**AEGIS LIVING** OF KIRKLAND

CONCEPTUAL DESIGN CONFERENCE #2  
AUGUST 21, 2017

**OPTION 1**

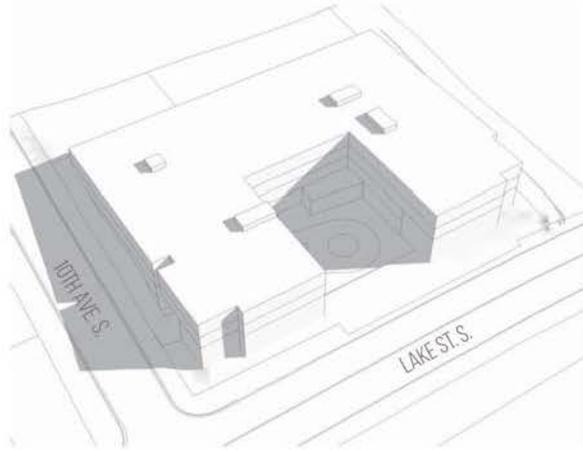
- RETAIL AT THE NW CORNER IS GOOD

**OPTION 2**

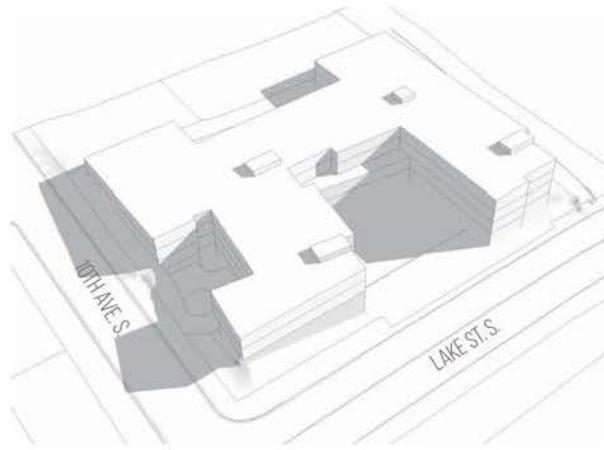
- RETAIL AT THE NW CORNER IS GOOD
- SEPARATION BETWEEN THE VEHICULAR ACCESS AND PEDESTRIAN ACCESS IS GOOD

**OPTION 3**

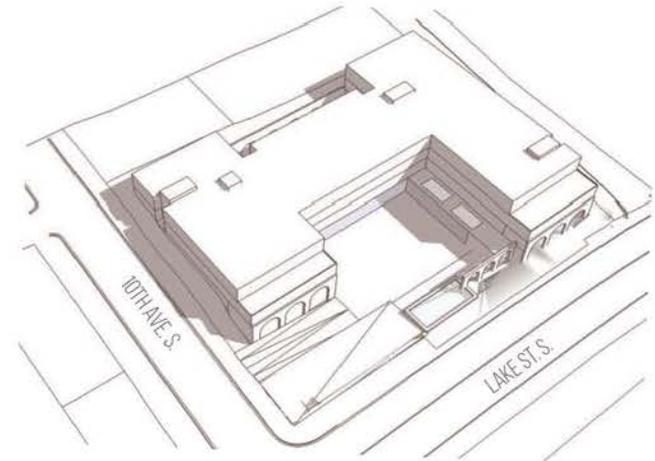
- STEP BACK MASSING IS GOOD
